Title - Sujet Fire Suppression System&Fire Alarm Fire Suppression System and Fire Alarm Replacement	
Solicitation No. - N° de l'invitation EP076-201304/A	Amendment No. - N° modif. 012
Client Reference No. - N° de référence du client 20201304	Date 2021-04-07
GETS Reference No. - N° de référence de SEAG PW-\$\$\$FG-374-79676	
File No. - N° de dossier fg374.EP076-201304	CCC No./N° CCC - FMS No./N° VME
Solicitation Closes - L'invitation prend fin at - à 02:00 PM Eastern Daylight Saving Time EDT on - le 2021-04-13 Heure Avancée de l'Est HAE	
F.O.B. - F.A.B. Plant-Usine: <input type="checkbox"/> Destination: <input checked="" type="checkbox"/> Other-Autre: <input type="checkbox"/>	
Address Enquiries to: - Adresser toutes questions à: Vani-Machado, Alba	Buyer Id - Id de l'acheteur fg374
Telephone No. - N° de téléphone (873) 355-4048 ()	FAX No. - N° de FAX () -
Destination - of Goods, Services, and Construction: Destination - des biens, services et construction:

Addendum 12

T58 Building Fire Suppression System Questions
Solicitation – EP076-201304

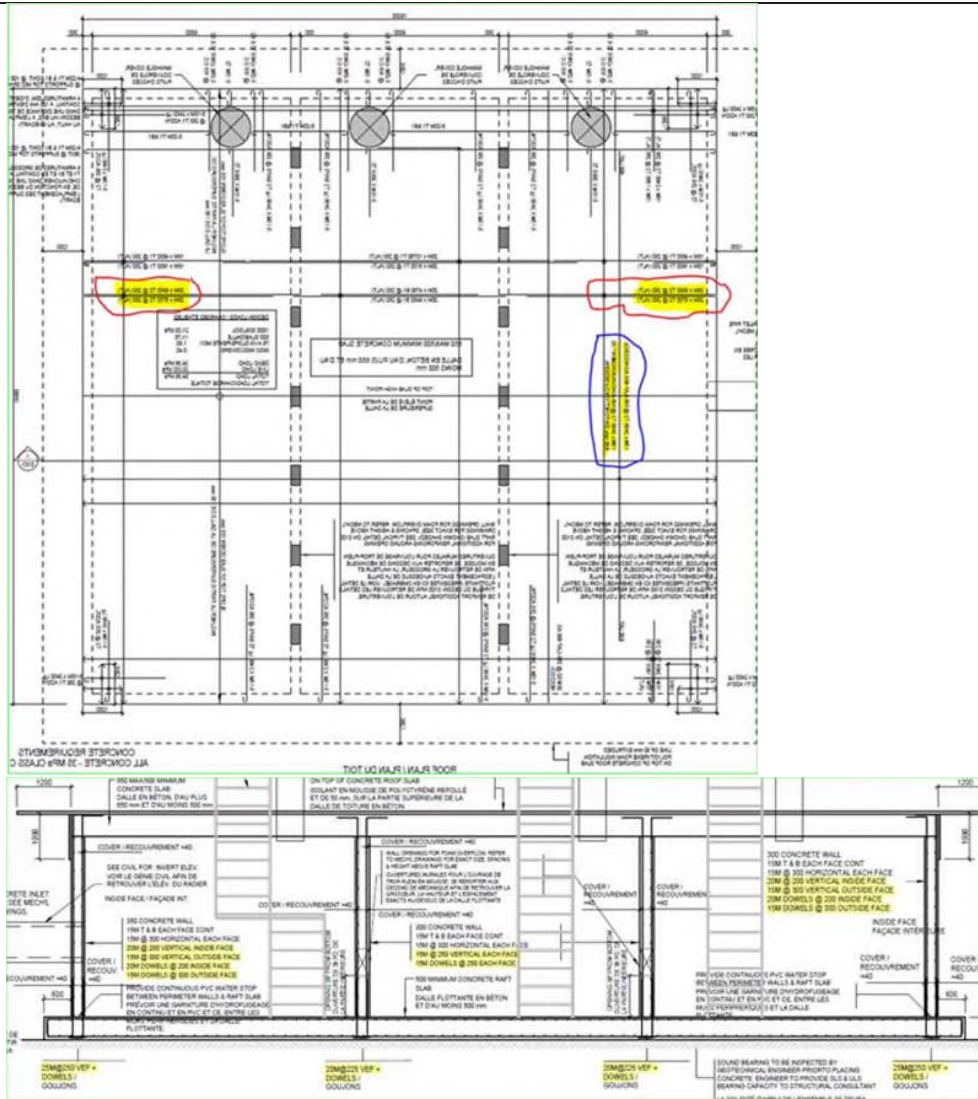
Q 30 - In drawing S102, section A-A/S101 – CROSS-SECTION, the wall reinforcement is shown on the side of each wall. Also bottom of each wall is shown vertical reinforcement which is different from the vertical reinforcement shown on the side of the walls. See section “A-A” below. Can you please clarify which vertical reinforcement should be used?	A 30 – We have revised our wall reinforcement in section A-A/S102, refer to clouded areas on S102 in addendum for further details.

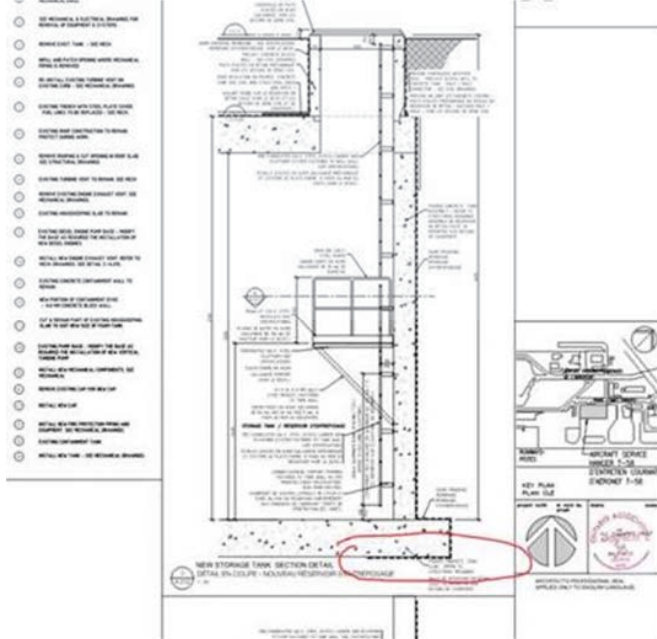
Q 31 - Phase plan T.000 indicates the requirement to install 300mm fire protection main pipe in phase 1A. However, work under phases 3A,B,C,D indicates rough-in for 300mm pipe. Please clarify in which phase the 300mm pipe will be completed?

Q 31 – as indicated in the phase 1A note, the 300 mm diameter pipe must be installed in its entirety across the hangar during Phase 1A to bring water to zone valves located in the new addition.

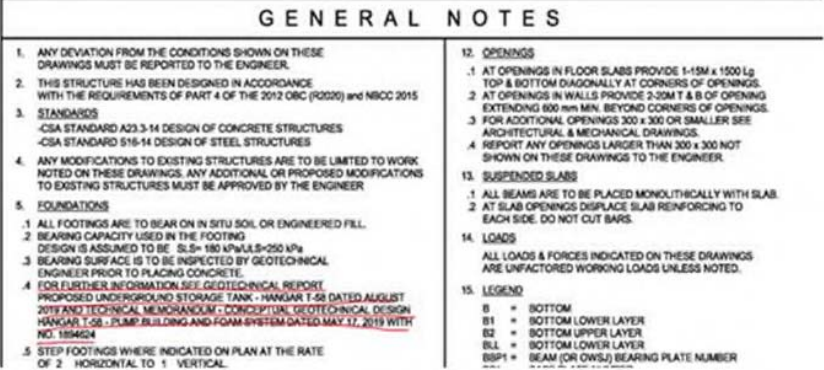
Q 34 - Considering that the construction of new valve room (phase 1A) and construction of new storage tank and exterior civil (phase 2) work will have some work overlap, can you please confirm if these phases (1A & 2) can be done at the same time?

A 34 – Phasing overlap is understood and acceptable. All construction activities and modifications to the phasing plan are subject to review and approval by Departmental Representative.

E.308

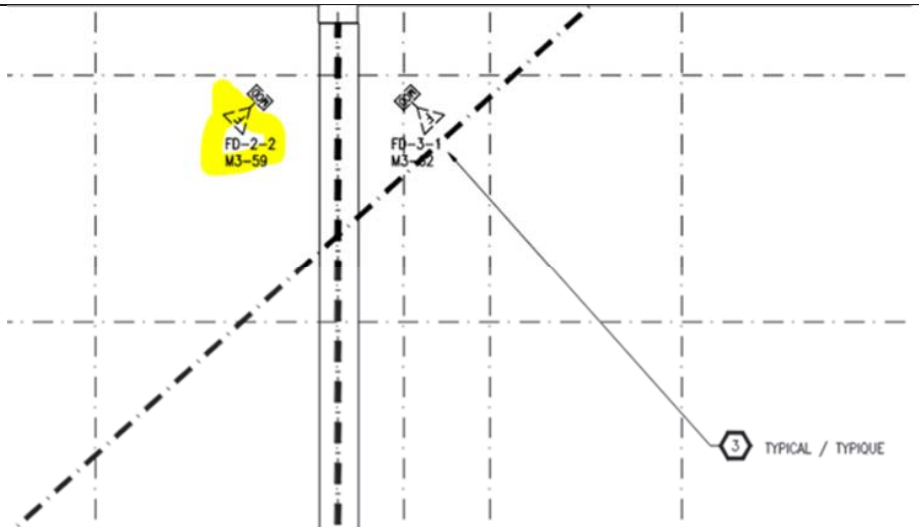
<p>Q 30 - In drawing S102, section A-A/S101 – CROSS-SECTION, the wall reinforcement is shown on the side of each wall. Also bottom of each wall is shown vertical reinforcement which is different from the vertical reinforcement shown on the side of the walls. See section "A-A" below. Can you please clarify which vertical reinforcement should be used?</p>	<p>A 30 – We have revised our wall reinforcement in section A-A/S102, refer to clouded areas on S102 in addendum for further details.</p>	
<p>Q 33 - For the new 300mm sprinkler main pipe to be installed in the hanger building, can you please confirm that no additional reinforcing are required for the roof structure to account for the added pipe load?</p>	<p>A 33 – We have provided a supplementary support detail for the new 300 mm sprinkler main pipe, refer to the clouded areas on S301 for further details in addendum.</p>	
<p>Q 54 – When comparing dwg E303 (note 9) and E308 (note 3) as well as comparing E304 (note 8) and E309, I am unsure if the intent is to have 2 sets of flame sensors at the same location (one at 5M AFF, and one at 1.2M AFF). Please confirm.</p> <div><p>9 TYPICAL FLAME SENSORS TO BE MOUNTED 1200mm A.F.F.</p><p>This typical note isn't pointing to a device.</p></div>		<p>A 54 – as noted on the documents there is two (2) sets of flame detectors. The lower flame detectors are mounted at 1200mm A.F.F. and the upper flame detectors are mounted at approximately 5-meter A.F.F.</p>

E.304

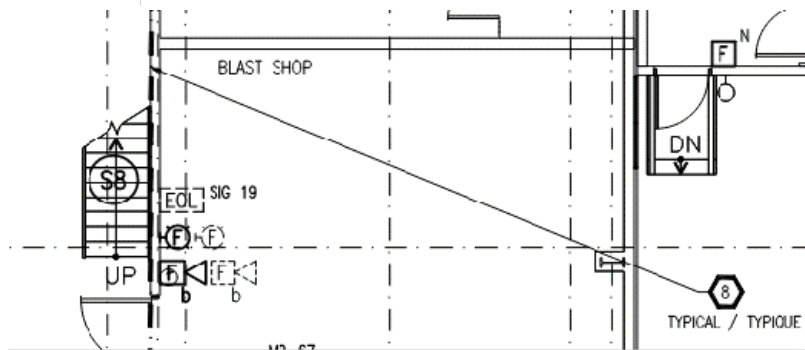
This typical note isn't pointing to a device.

E.309

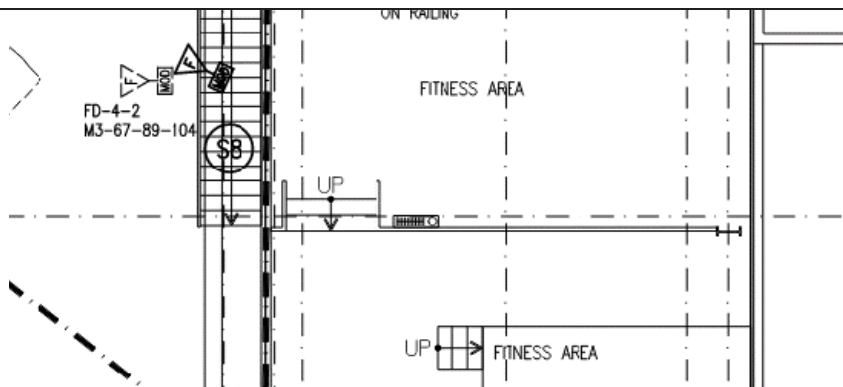
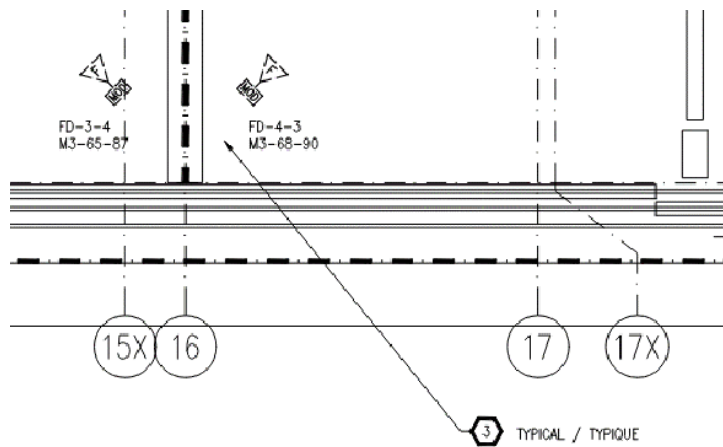
(is this the same as shown on E304, note 8?)

Q 55 - In regards to the flame detectors, can you confirm that all of the existing flame detectors shown are to be replaced with new? Typically existing fire alarm devices are shown on the drawings to be removed with new devices shown next to these, but for the flame detectors, only the existing ones are shown with a typical note to provide a new one.

A 55 – All flame detectors are to be replaced.
